# **Dell Avenue Solar Project**

***Re: Dell Avenue Solar Farm Project  
 Application for Site Plan and Special Use Permit  
 Tax Map Parcel 70.15-1-2 & 70.11-1-16 (“Property”)***

## Dell Avenue Solar Farm Site Plan & Special Use Permit – Comment Response Log

**Town of Yorktown Building Department Memorandum, re: Dell Ave Solar Farm July 25, 2022**

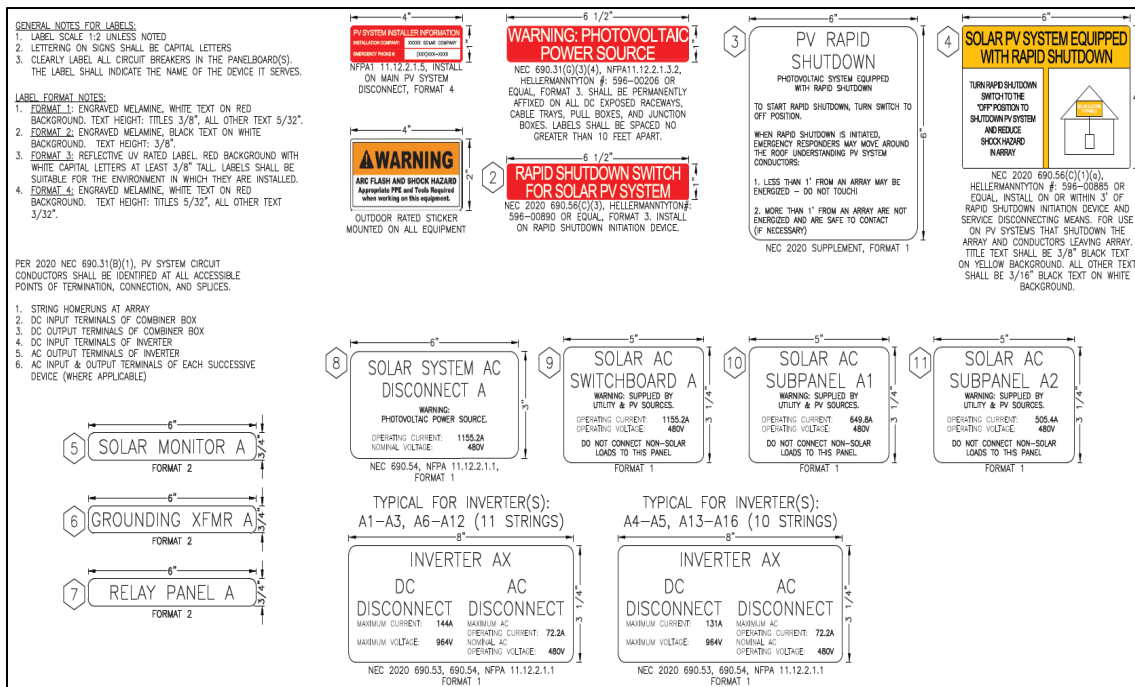
*Compliant signage shall be provided throughout the installation including emergency contact information which shall be displayed on every access gate.*

Upon receiving the Building Department Memorandum on Aug 02, 2022, an example photo of (compliant) emergency contact signage was shared with the Town of Yorktown Building & Fire Inspector via email and an affirmative response was replied. The photo and additional example signage is included below. These are not typically finalized this early in the project development phase, and therefore are not intended to be included in the Site Plan Set, but they are a requirement for all Sol Customer Solutions projects. The applicant fully agrees to the request for compliant signage to be provided throughout the facility, including emergency contact information displayed at both access gates.
